PROJECT: CLIFF'S EDGE PODs 201 & 203 - UNIT 5
(AKA CAMBRIDGE VILLAS / CAMBRIDGE CROSSING)

**ADDENDUM # 1
TO UPDATE #3 TO
TECHNICAL DRAINAGE STUDY**

**CLIFF'S EDGE
PODS 201 & 203 – UNIT 5
(aka Cambridge Villas/Cambridge Crossing)**

SUBJECT: ADDENDUM #1 TO UPDATE #3 for THE TECHNICAL DRAINAGE STUDY
FOR: CLIFF'S EDGE PODS 201 & 203 UNIT – 5 (aka Cambridge
Villas/Cambridge Crossing)

PULI-PL-AD1 Plan: Plan 07 12/14/2010
 River = Puli Reach = PULI-HEC-RAS RS = 350

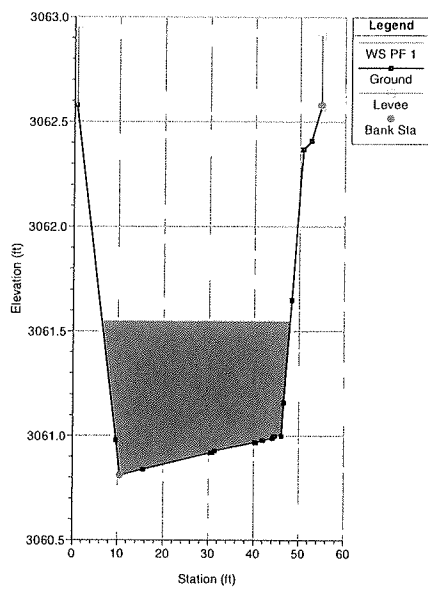
3. On the west boundary, according to the *HEC-RAS Exhibit*, the "Min Ch El" column show uneven bottom elevations which results in uneven flow depths along the river stations. At one point (River Station 3+50.00), the flow depth (or ponding depth) behind the flood wall is 6.7' which is not acceptable. It appears that the existing grades along the back of the proposed flood wall does not provide for positive drainage in a southerly direction. The engineer is advised to meet with Flood Control staff to resolve this issue prior to the submittal of the next addendum.

Based on the meeting with Flood Control staff on 11/18/2010, the street design on Puli Road has been revised to provide positive drainage in the southerly direction, by revising the temporary flowline on Puli Road to match the design subgrade of the approved Puli Road improvement plans. Since the schedule of the construction for Puli Road is currently unknown, the proposed wall on Puli Road will be flood protected to the ultimate condition as shown per the approved Master Drainage Study for Cliffs Edge. Riprap lining along the wall is proposed as temporary erosion protection until the construction of future Puli Road.

Please note that at River Station 3+50.00, the actual water depth is 1.43'. The depth of 6.7' was the difference of the minimum channel elevation and the water surface elevation, which is incorrect. The cross section submitted previously includes additional area to the west (to show the geometry of the existing ROW) which is much lower than the existing ground. Levee option was used to contain the water closer to the proposed wall as a conservative approach for flood protection. In order to eliminate this confusion, the revised cross sections in this submittal have been truncated to show actually conveyance channel only. The hydraulic calculation (HEC-RAS) and the HEC-RAS Exhibit have been revised accordingly to reflect the changes. Please refer to the Appendix for revised hydraulic calculations.

REVISED GRADING PLANS

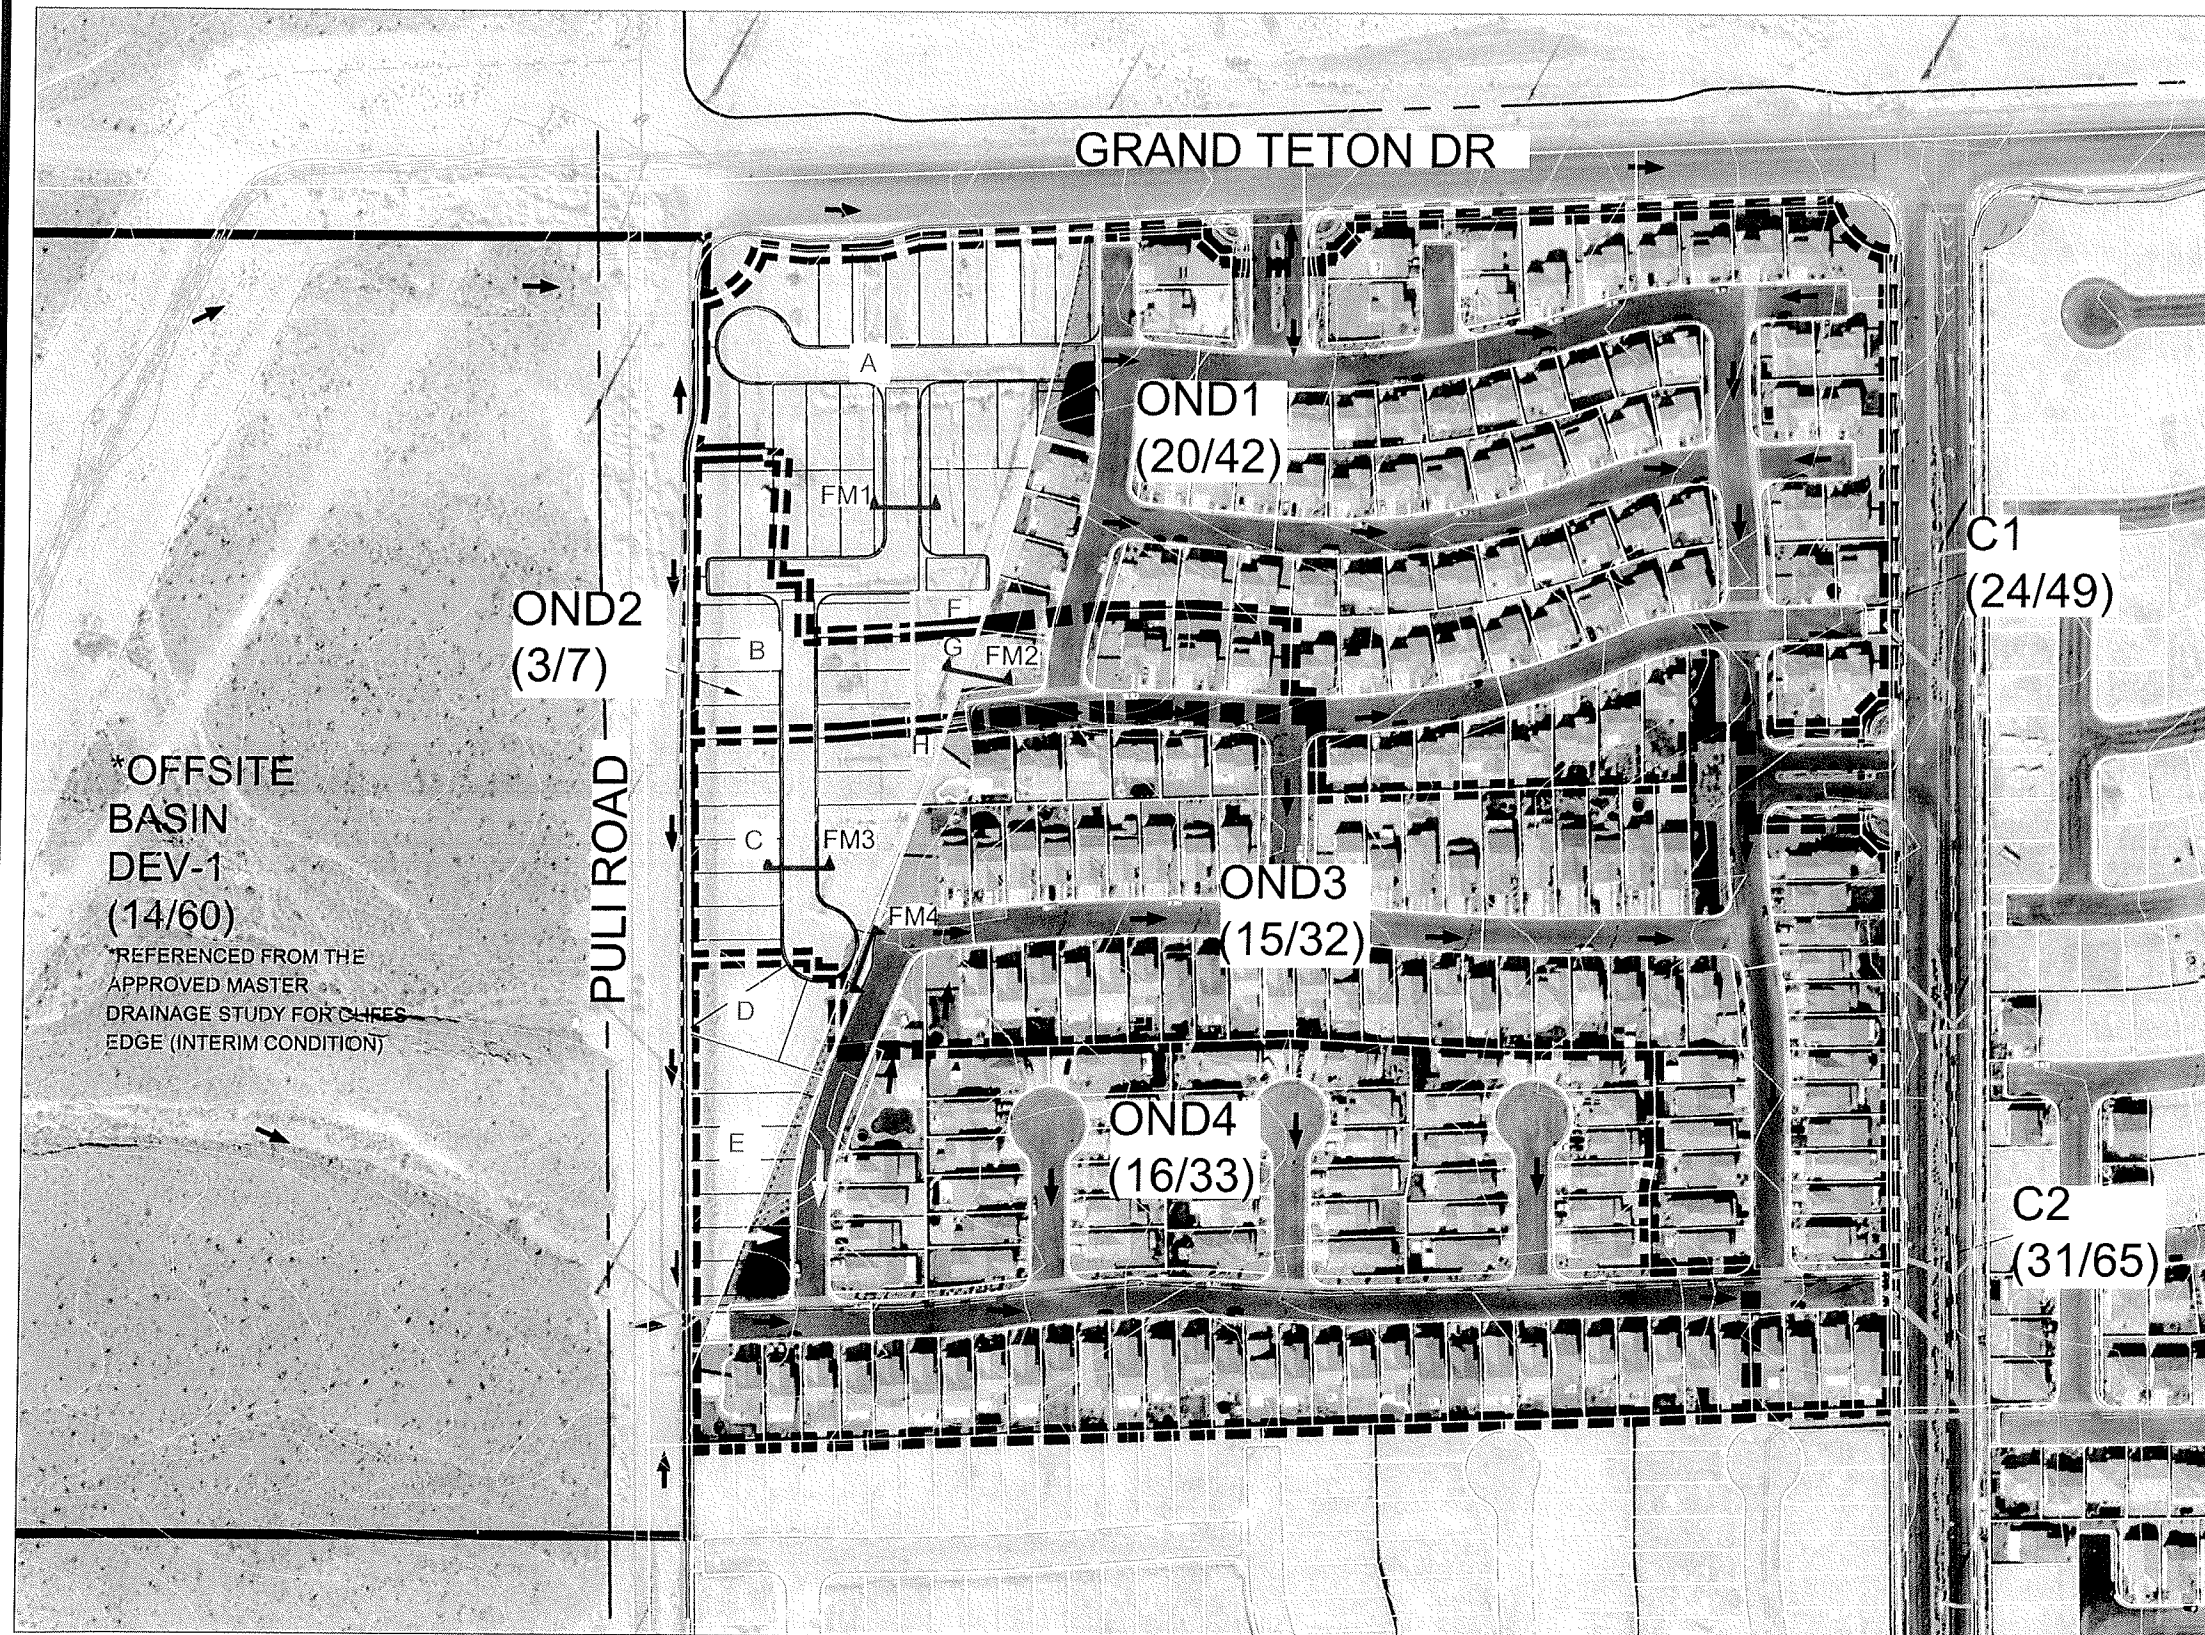
6. **Sheet G1:** Extend a proposed concrete valley gutter along the east boundary northerly to meet Brighton Beach Avenue.

The grading for lot 345 has been revised and the need for concrete valley gutter has been eliminated. Please refer to the revised plans in Appendix for detail.
